AUS920010753US1

D. AMENDMENTS TO THE DRAWINGS

Applicant submits three replacement sheet drawings (see section F) and requests amendment of the drawings as follows:

Replacement Sheet 3/15 FIG. 4

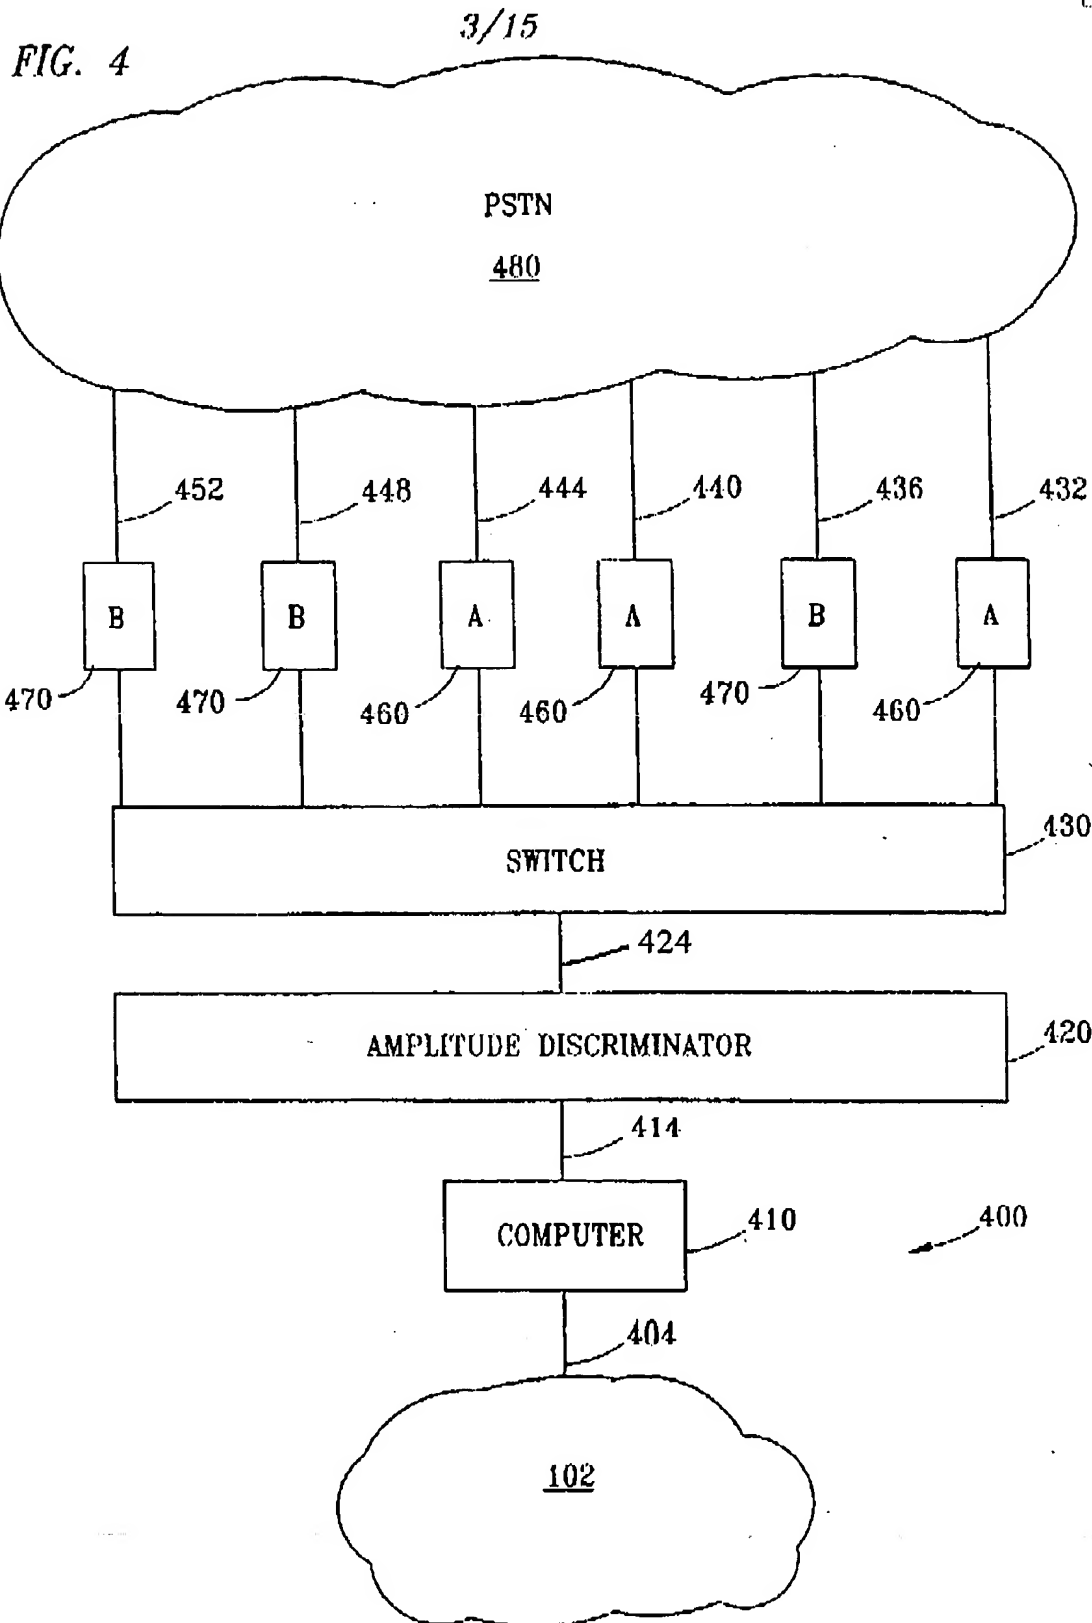
Sheet 3/15, FIG. 4 has been amended to add the numeral 424 to the line connecting switch 430 and amplitude discriminator 420. On page 8, lines 22- page 9, line 1, the specification states "Amplitude discriminator 420 is connected to switch 430 by line 424. The numeral 424 was inadvertently left off the original drawings, and a substitute drawing is provided attached to this response.

FIG. 5

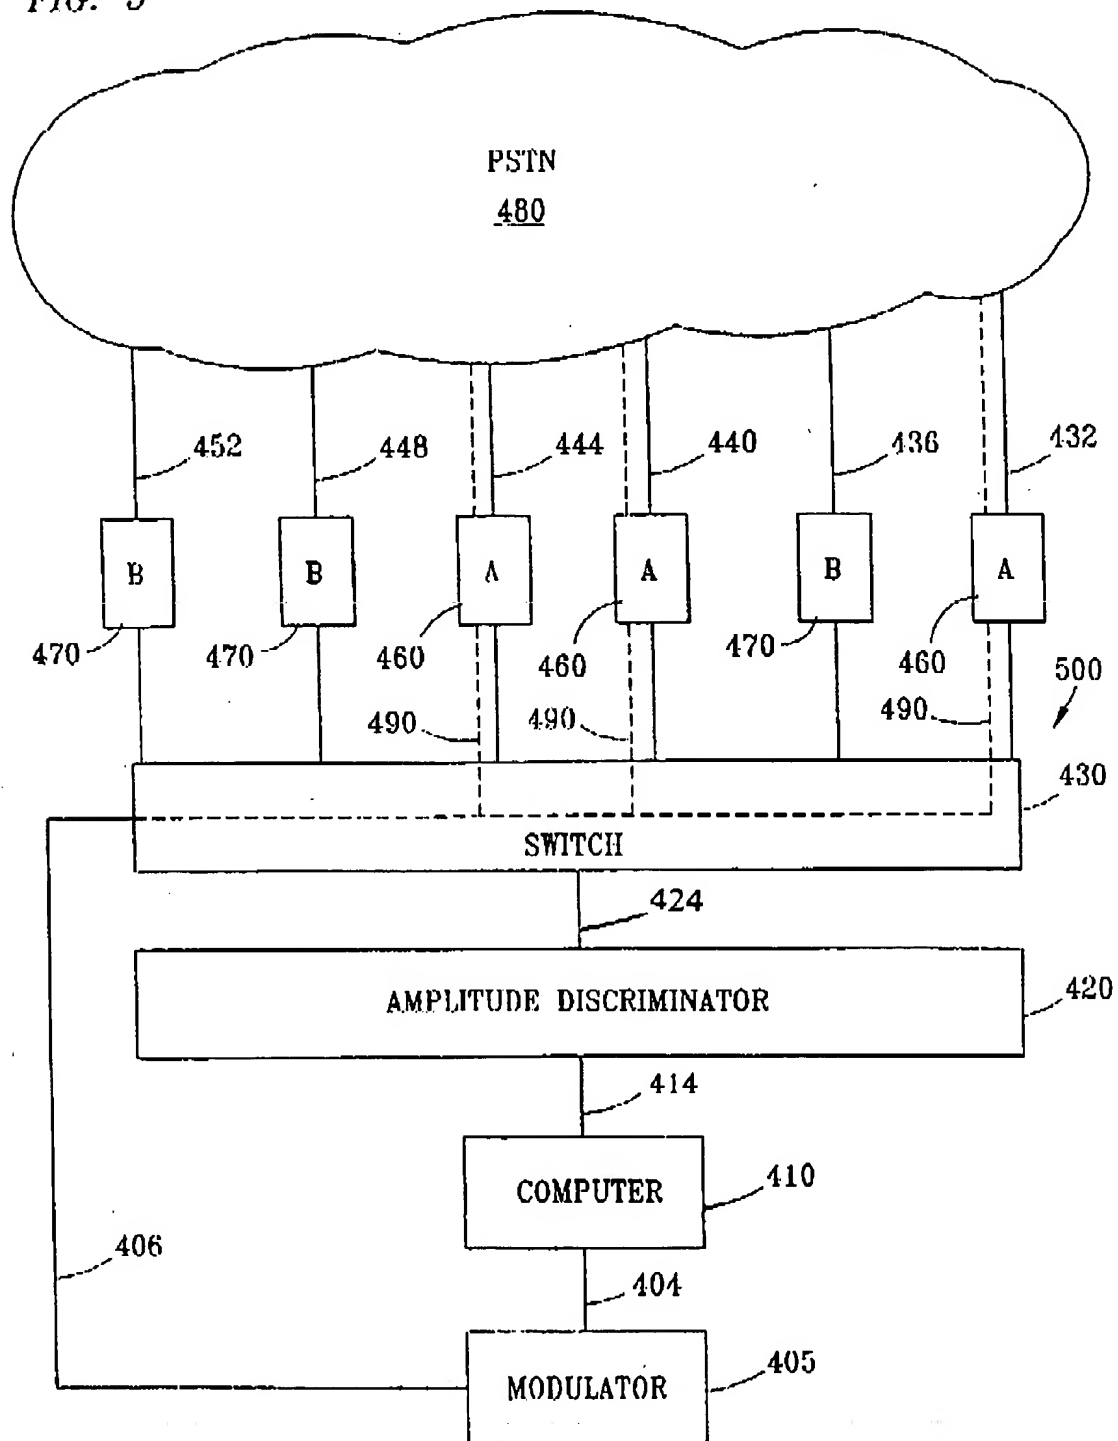
Sheet 4/5, FIG. 5 has been amended to add the numeral 424 to the line connecting switch 430 and amplitude discriminator 420. On page 9, lines 18-19, the specification states "[a]mplitude discriminator 420 is connected to switch 430 by line 424." The numeral 424 was inadvertently left off the original drawing, and a substitute drawing is provided attached to this response for correction.
